Pentium® II Xeon™ Processor Specification Update

Release Date: August 1998

Order Number: 243776-004

The Pentium® II Xeon™ processor may contain design defects or errors known as errata which may cause the product to deviate from published specifications. Current characterized errata are documented in this Specification Update.

Figure 1. An Example of Microcontroller Driven Thermal Management

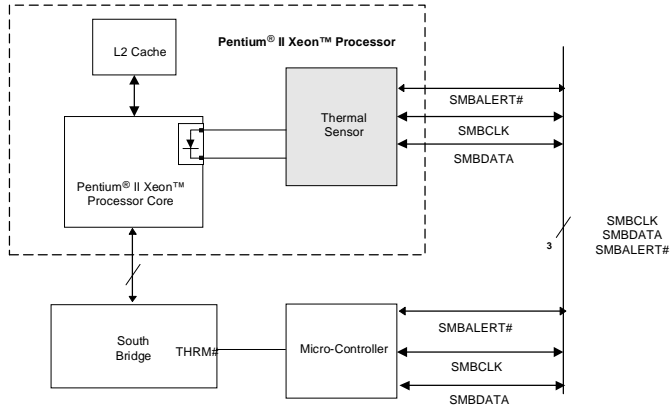
30. Thermal Sensor May Assert SMBALERT# Incorrectly

PROBLEM: The Pentium II Xeon processor has a thermal sensor that monitors the processor core's temperature. The thermal sensor asserts SMBALERT# if the processor temperature exceeds the temperature limits set in the Alarm Threshold Registers (T_{HIGH} , T_{LOW}). It also sets the corresponding Status Register bits to identify the cause of the interrupt. Figure 1 gives one example of the how the SMBALERT# signal could be used in a system.

Under the conditions described below, the thermal sensor incorrectly generates the SMBALERT# interrupt. *All* of the following conditions must be met to trigger a false interrupt:

WORKAROUND: Three different (mutually exclusive) workarounds are possible:

1. Before servicing an interrupt from the thermal sensor, read and compare the processor thermal reading with the threshold limits (T_{HIGH} or T_{LOW}). Figures 2 and 3 provide basic flowcharts for the implementation of this workaround in an interrupt driven system.
2. If the firmware implemented polls the Status Register only, then before taking any action, re-read the temperature register and do a comparison with the alarm threshold limits (T_{HIGH} or T_{LOW}) to determine if the value is actually still within the temperature window.
3. Use a temperature polling scheme to monitor the processor temperature.
